AGENDA

President and Board of Trustees
Village of Arlington Heights
Board Room
Arlington Heights Village Hall
33 S. Arlington Heights Road
Arlington Heights, IL 60005
July 20, 2015
8:00 PM

Address: Chuck-E-Cheese
41 W. Rand Road
Special Use for a Restaurant, Amusement Device Arcade
P.C. #15-008
Round 1

SHEET
A9.0
OF 22

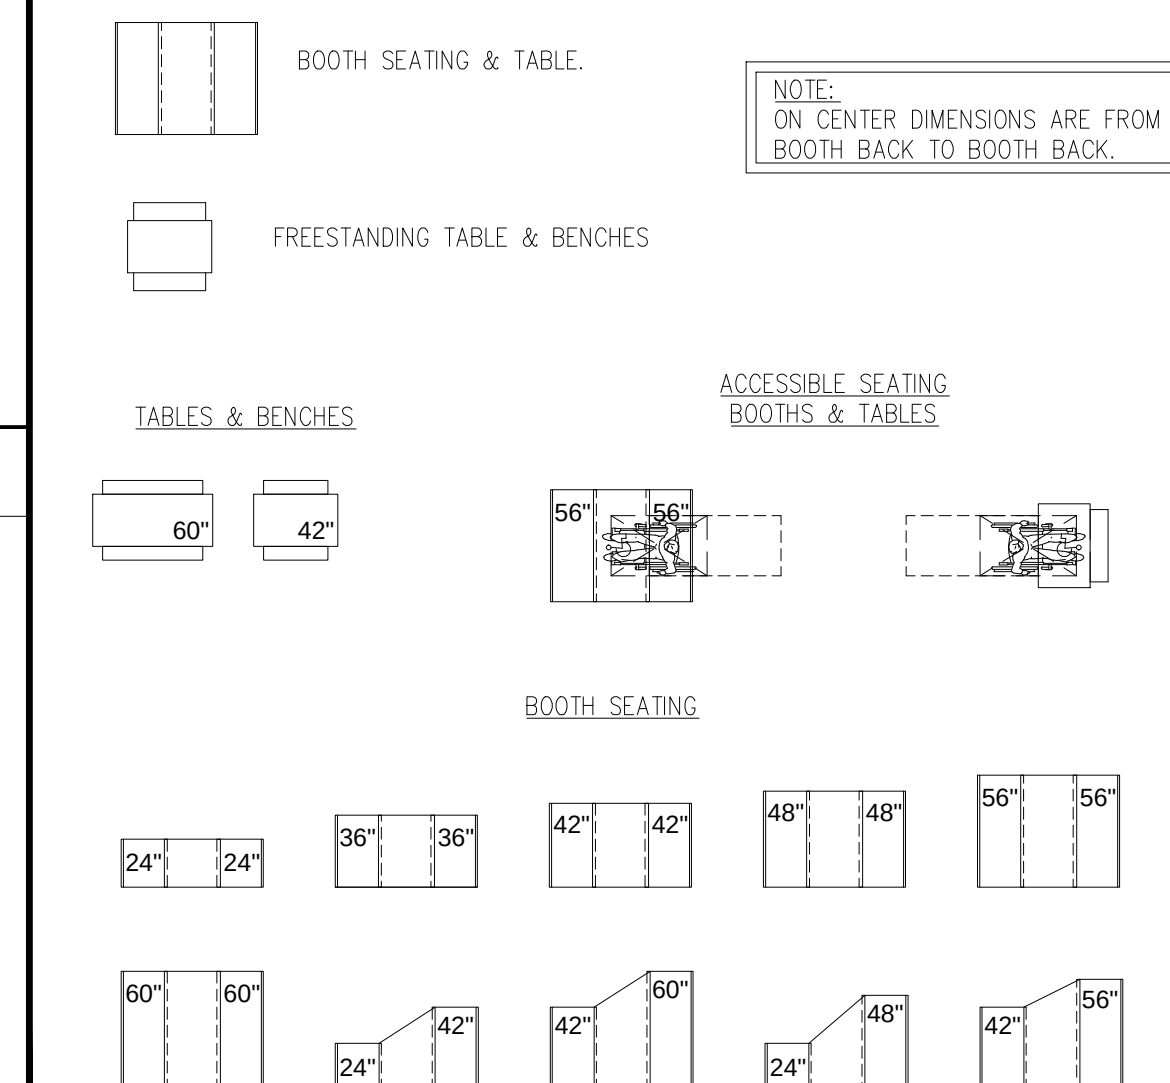
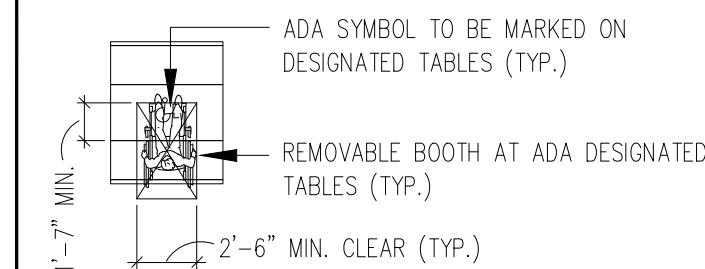
Sheet A9.0

SHEET NO.
C1

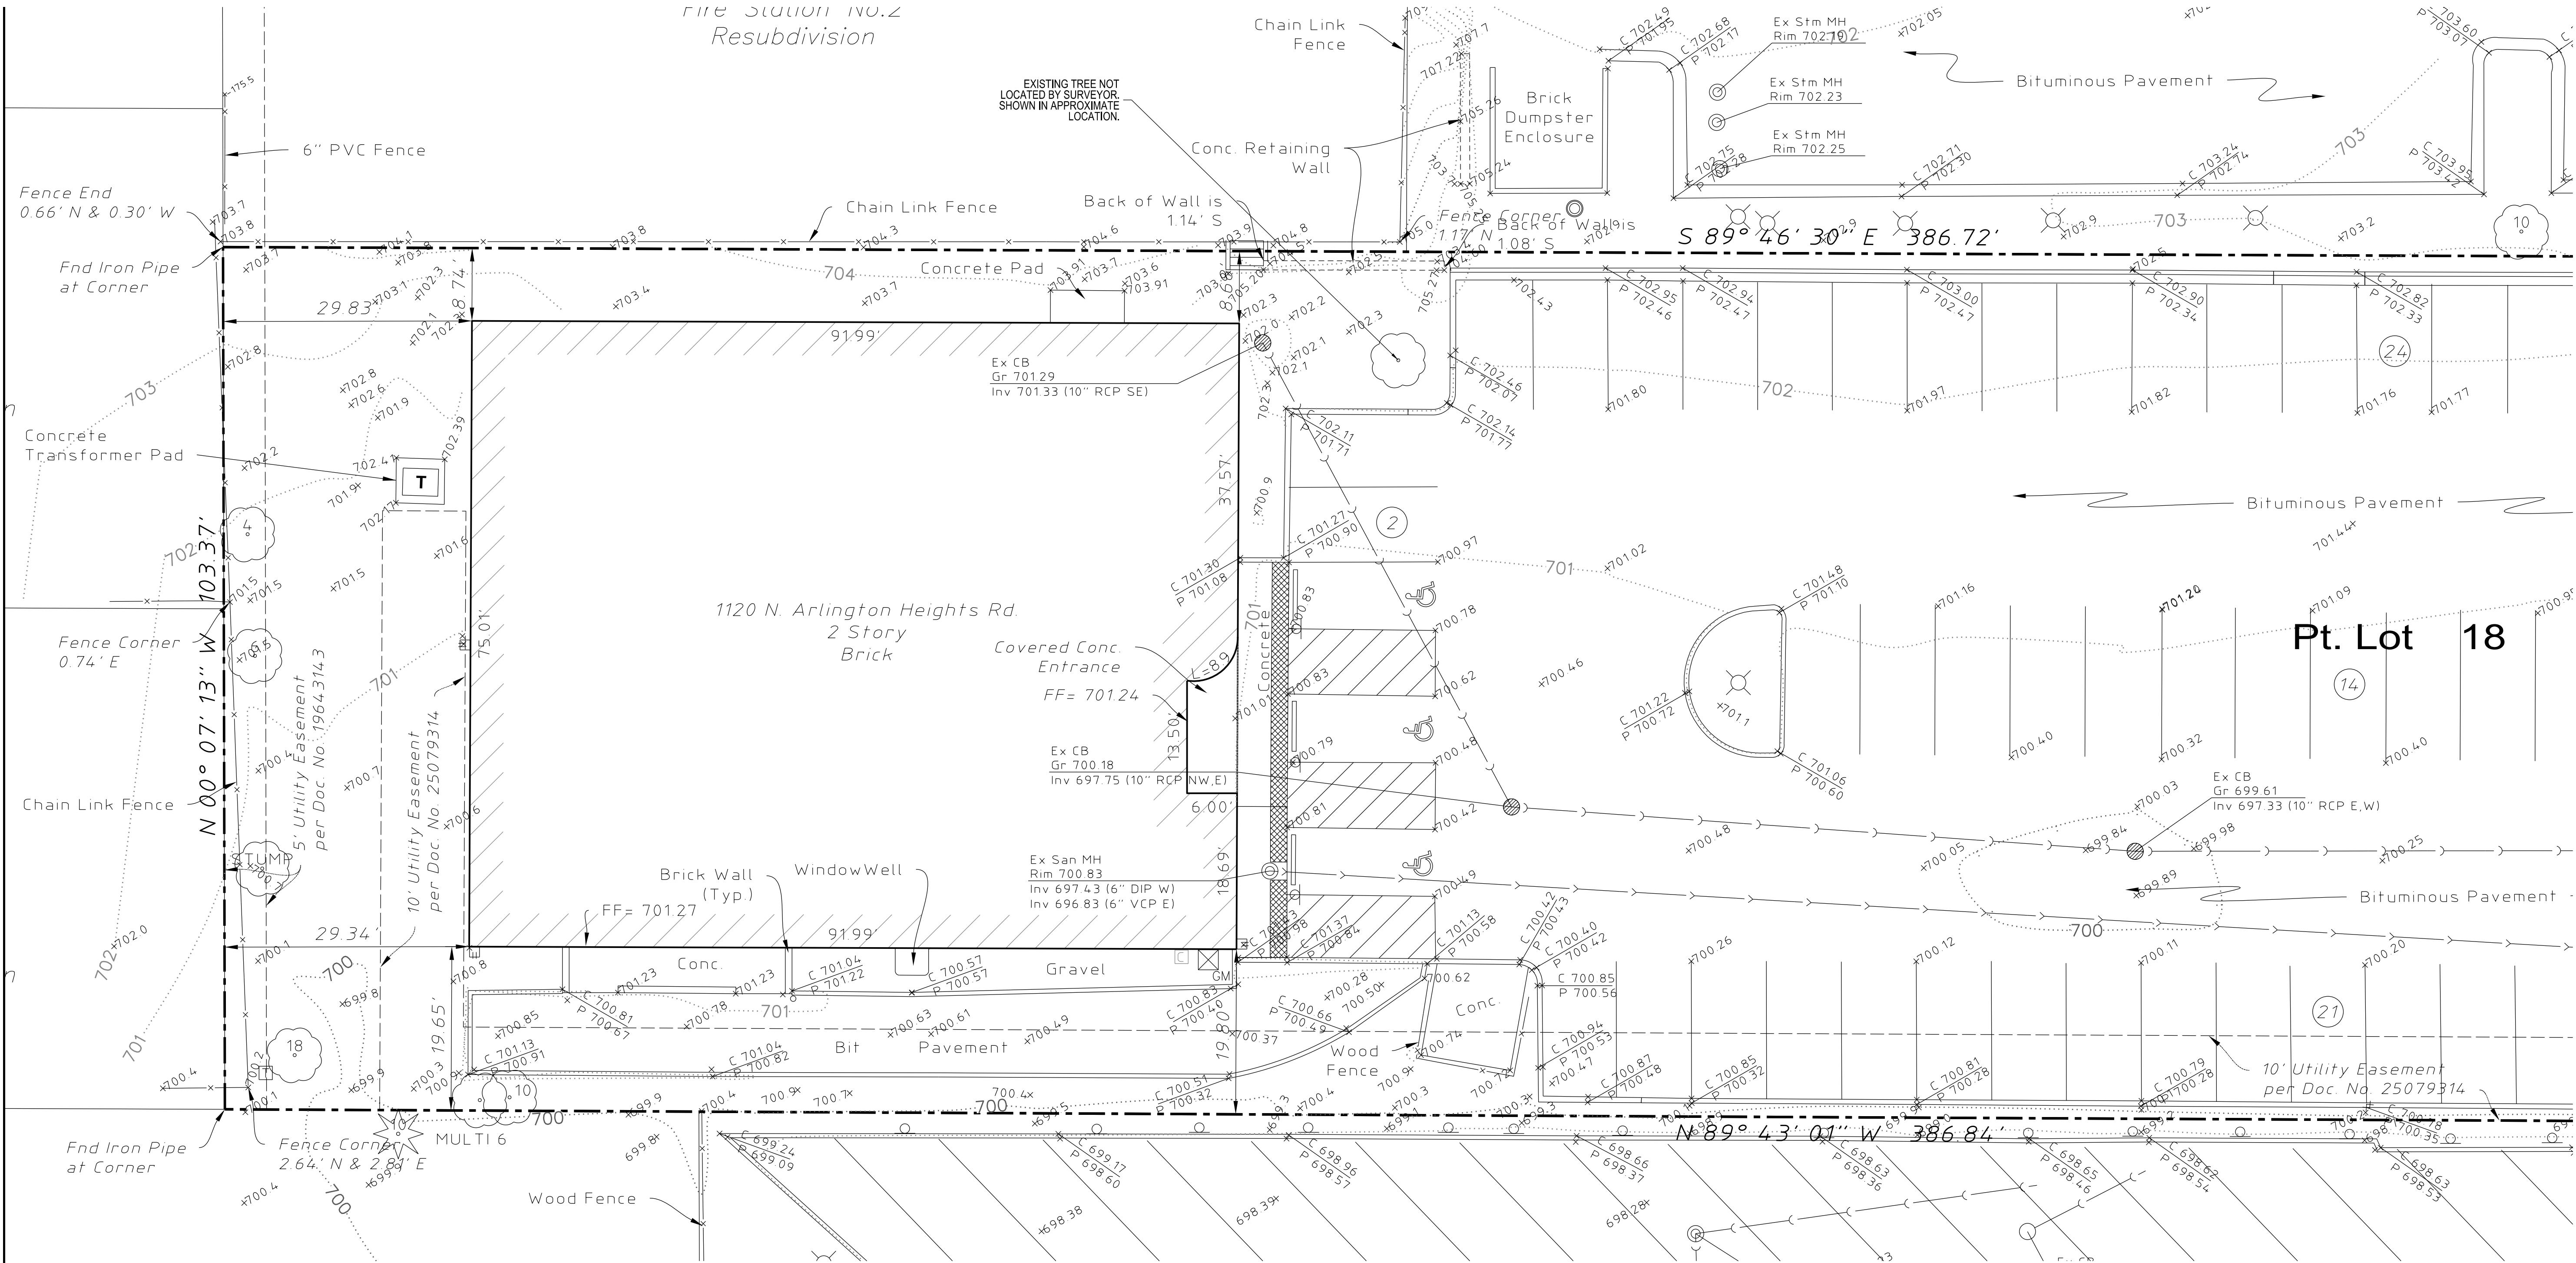
12. The proposed plan shows a reduction in the overall impervious area for this site. According to the project description on sheet C1, some of the area is "...permeable rubberized safety play surfaces." Provide a cross-section detail of this play area. Provide manufacturer's data showing the product specifications so a determination can be made as to whether or not this can be considered permeable.

2. The proposed plan shows a reduction in the overall impervious area for this site. According to the project description on sheet C1, some of the area is "...permeable rubberized safety play surfaces." Provide a cross determination can be made as to whether or not this can be considered permeable.

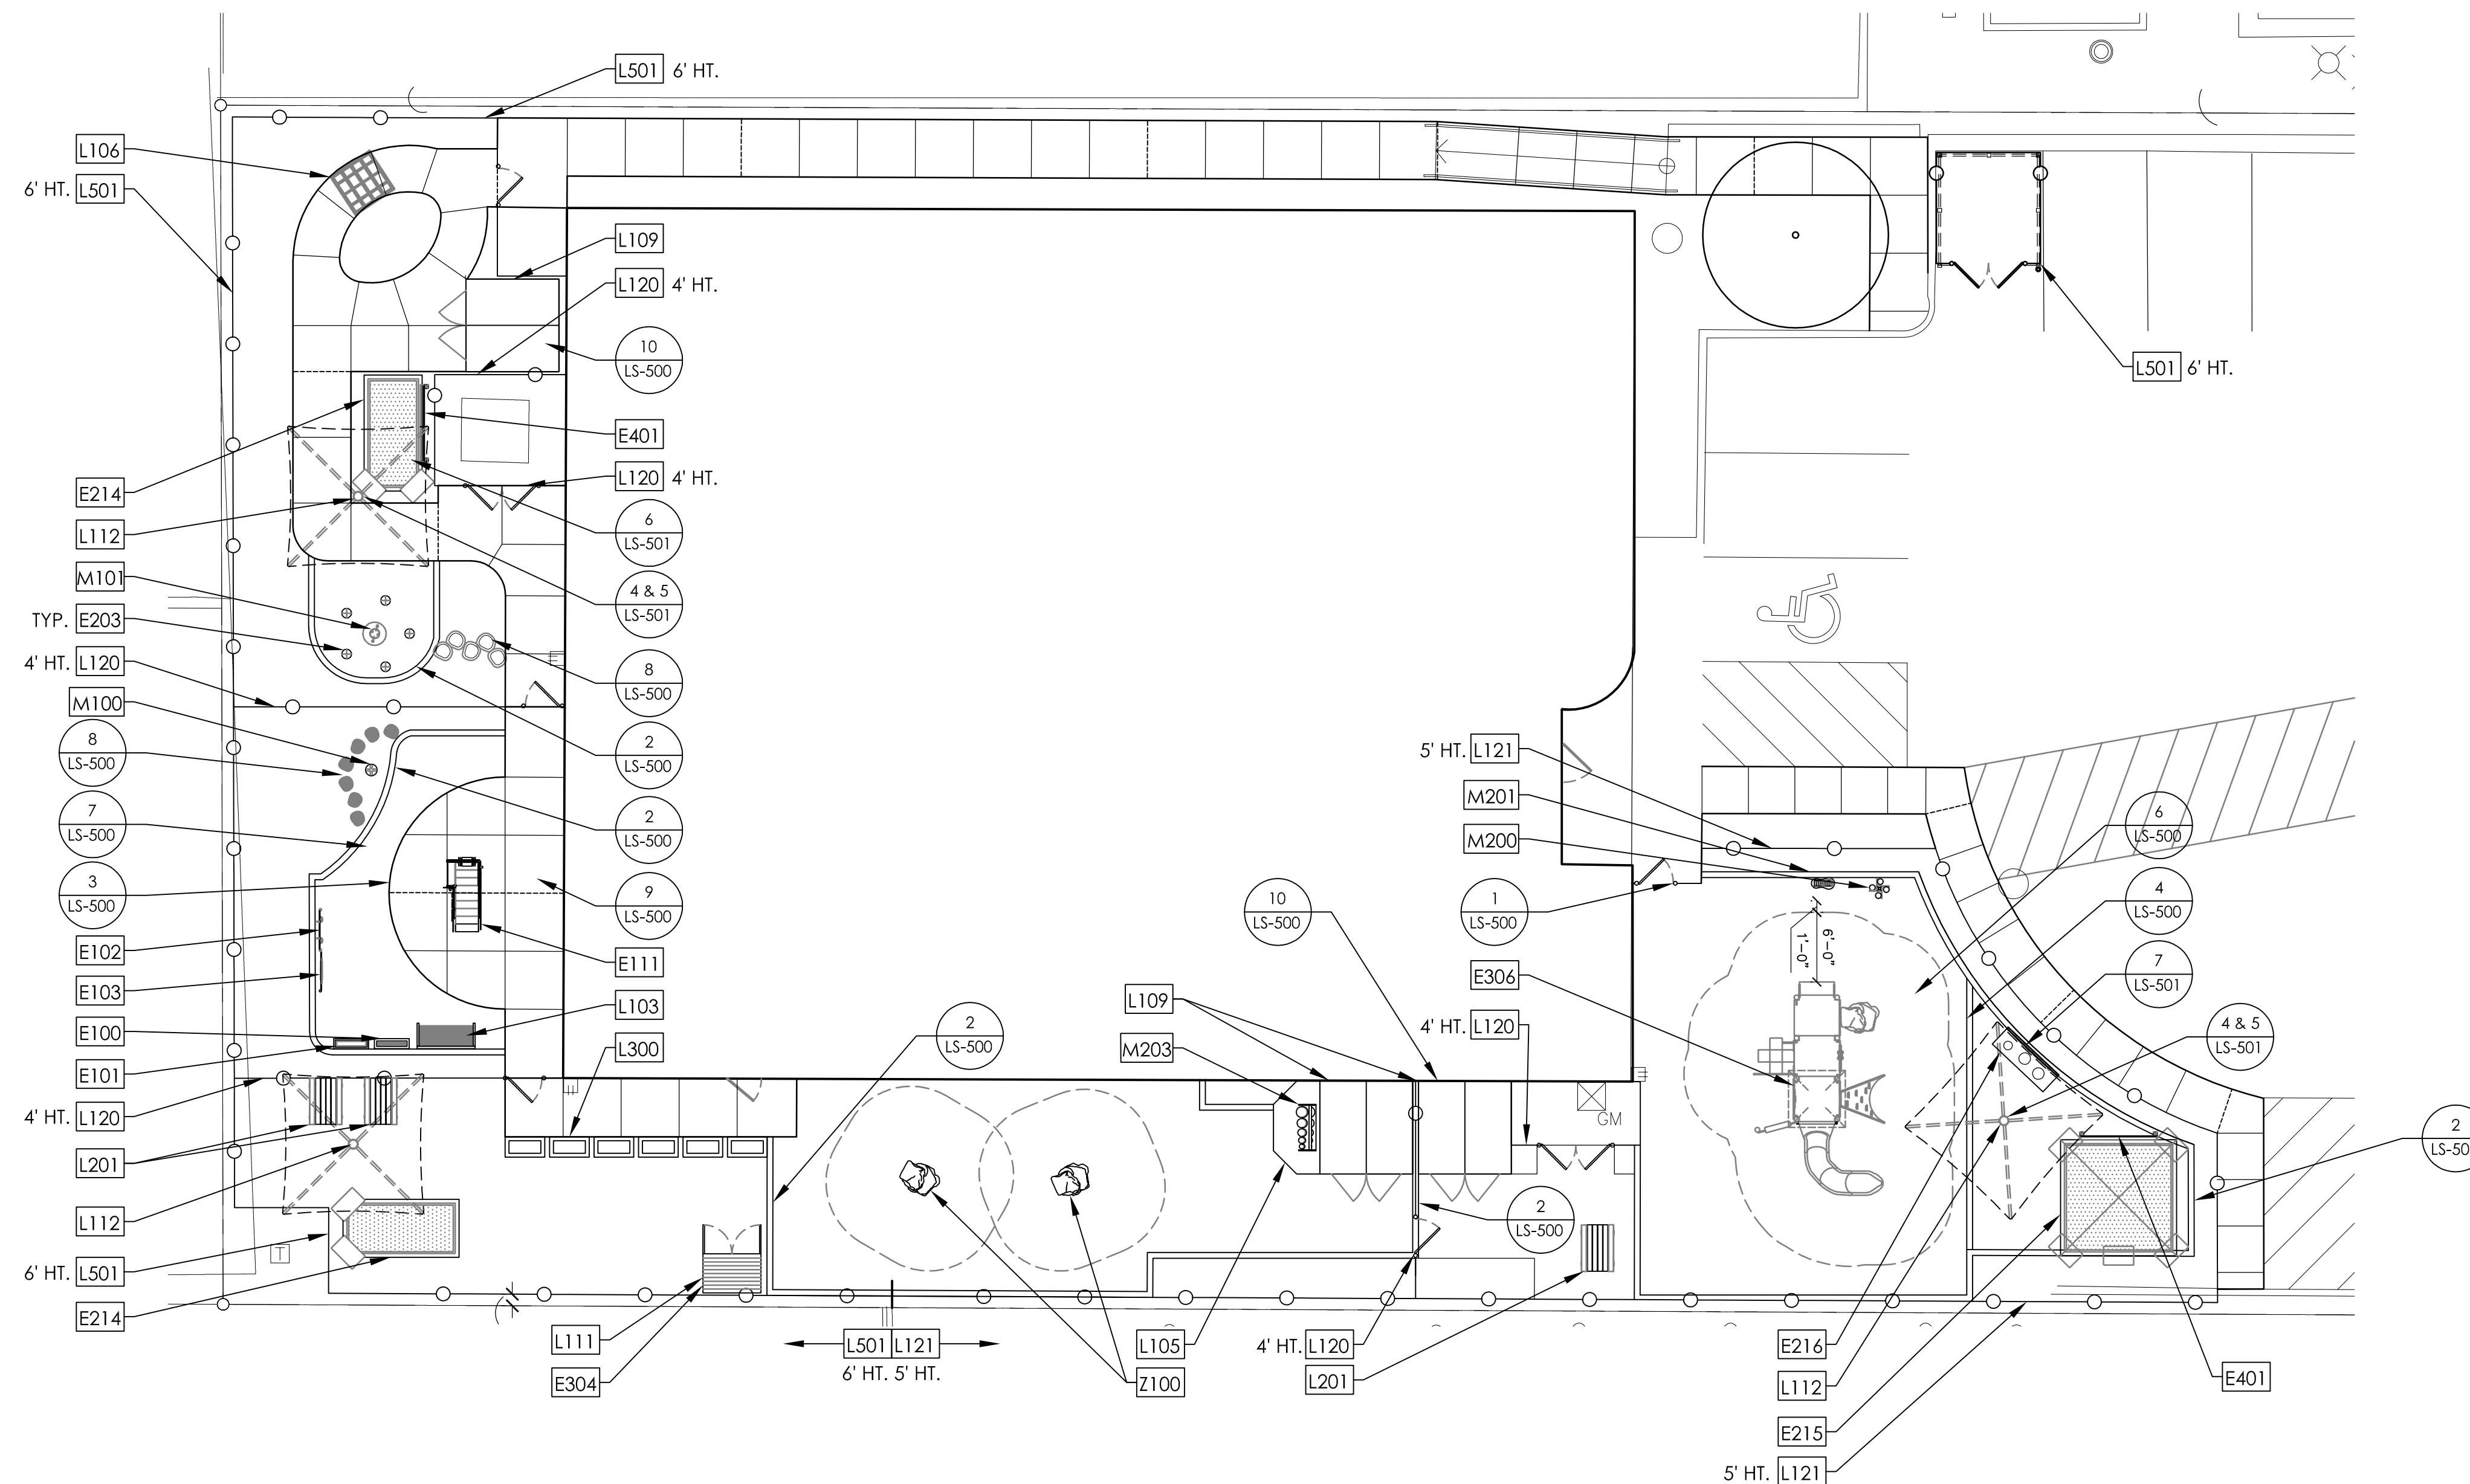
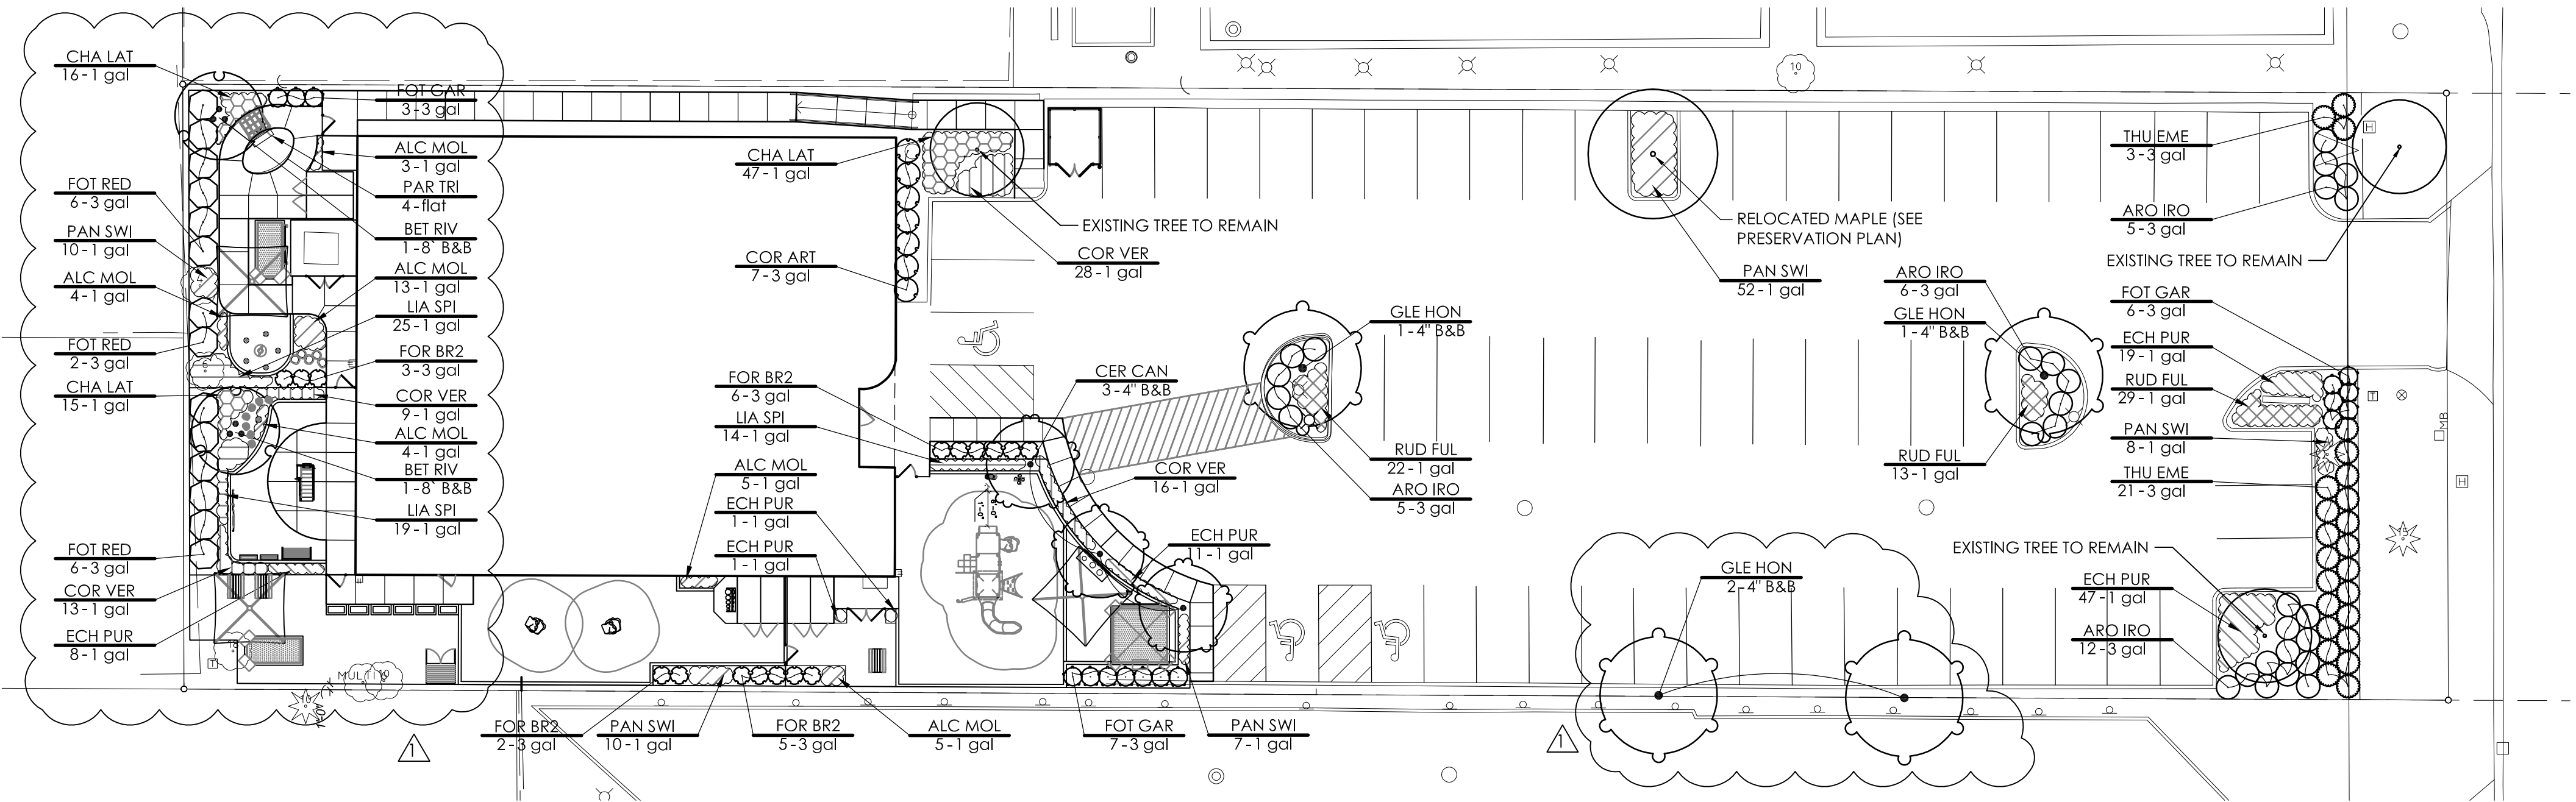
It should be noted that there is an inconsistency on Sheet LS-101 which calls out a 5 foot fence on the plans, but lists a 6 foot height on the equipment schedule. The petitioner has verbally confirmed that they are requesting a 5 foot tall fence.

- 12. Per Chapter 28, Section 6.15-2.2, a 6 foot high solid screen is required between a property in a business district and adjacent residential district. The property in questions abuts residential property on the west and for a portion of the south property line. Sheet L1.0 identifies the fence as a L501, 6 feet high fence with 8 feet wide panels. The cut-sheet provided in the binder identifies the fence as 'Alabama Style Vinyl Fence' with picket spacing and lattice top. Please revise. Fence must be 6 foot high, solid fencing. Please note that the fence along the south property line that does not abut the residential property must be 5 feet tall, semi-open fence.

12. Per Chapter 28, Section 6.15-2.2, a 6 foot high solid screen is required between a property in a business district and adjacent residential district. The property in questions abuts residential property on the west and for a portion of the south property line. Sheet L1.0 identifies the fence as a L501, 6 feet high fence with 8 feet wide panels. The cut-sheet provided in the binder identifies the fence as ‘Alabama Style Vinyl Fence’ with picket spacing and lattice top. Please revise. Fence must be 6 foot high, solid fencing. Please note that the fence along the south property line that does not abut the residential property must be 5 feet tall, semi-open fence.

Response: Acknowledge, see sheet LS101.

Ok. Sheet LS101 shows the fence along the west property line and for a portion of the south property line as vinyl solid board privacy fencing. The fence along the remainder of the south property line and along the play area is 5 feet tall metal fence with 3 inch picket spacing.
